## OICA position on keeping the size of the exemption zone in the bonnet leading edge area

EuroNCAP Child Head Results for SUV  
with BLE Rearwards of WAD1000

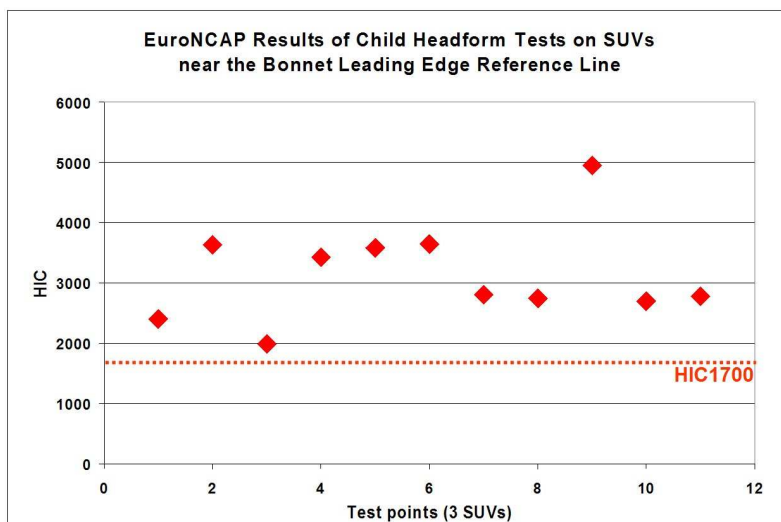
1	Bonnet leading edge (headlight)	HIC 2749
2	Bonnet leading edge (grille)	HIC 4949
3	Bonnet leading edge (grille)	HIC 2694
4	Bonnet leading edge (bonnet catch)	HIC 2778

Although these results were obtained with the 2.5 kg impactor at 40 km/h it is not expected that the HIC would be halved under draft GTR / draft EU Phase 2 / TRIAS 63 conditions. These results clearly demonstrate the feasibility problems that exist in this area. In addition, the exemption zone already exists in the European as well as in the Japanese legislation. For continuity in evaluation of the vehicles, the 165 mm should be maintained in the GTR.

Figure 1. 6-Year old kinematics with SUV (Matra/TNO feasibility study)

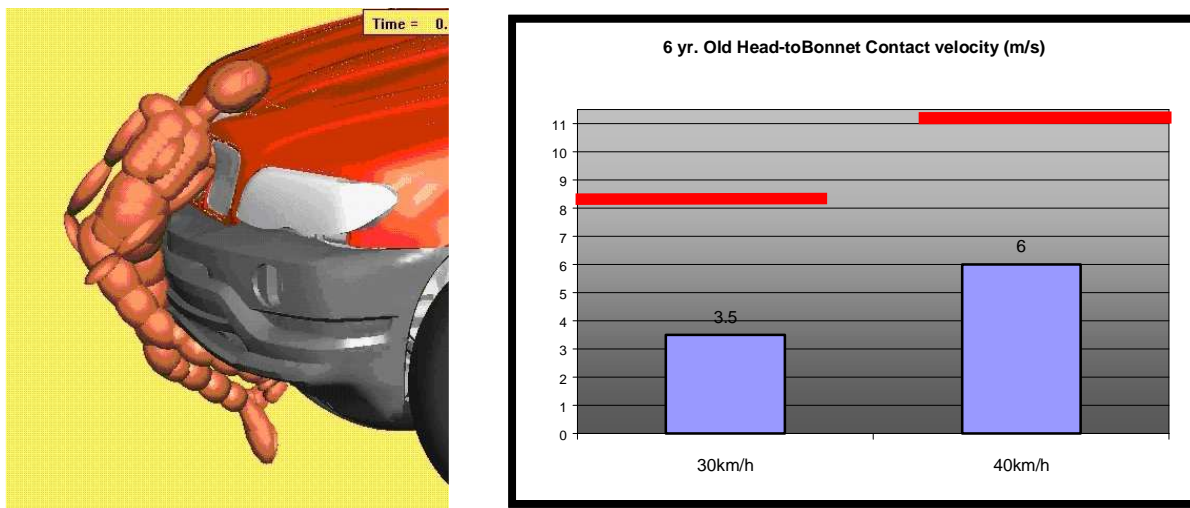
For vehicles with high bonnet leading edges the pedestrian (almost exclusively children) head impact speed to the bonnet leading edge area is significantly lower than the car to pedestrian collision speed. This is because the acceleration of the whole body occurs much earlier than in the case of adults. This leads to the low relative velocity between the bonnet and the head. Figure 1 shows the kinematics of a 6-year-old child and a typical SUV vehicle. The diagram on the right shows the relative head impact velocity compared to the car to pedestrian collision speed. The vehicle front has been modified in an attempt to meet the WG17 requirements (Matra/TNO feasibility study carried out for ACEA). It can be seen that at 40 km/h the relative head impact speed is approximately half the vehicle collision speed.

Investigation of the results from JARI simulations in the framework of IHRA activities show that the relative child head impact speed for the bonnet area immediately rearward of the bonnet leading edge is around 27 km/h at a collision speed of 40 km/h. This confirms the above findings.

Mandatory testing at 35 km/h in the area immediately rearward of the bonnet leading edge will therefore not bring the anticipated effectiveness. Given the above-mentioned feasibility problems in this area, attention should be paid to the requirements and test conditions before taking any decision on the extension of the child headform test area.

OICA therefore urgently requests the retention of the current and worldwide harmonized value of 165 mm for the relevant vehicle shapes, which is absolutely needed for the development of feasible designs in the contemplated time frame.
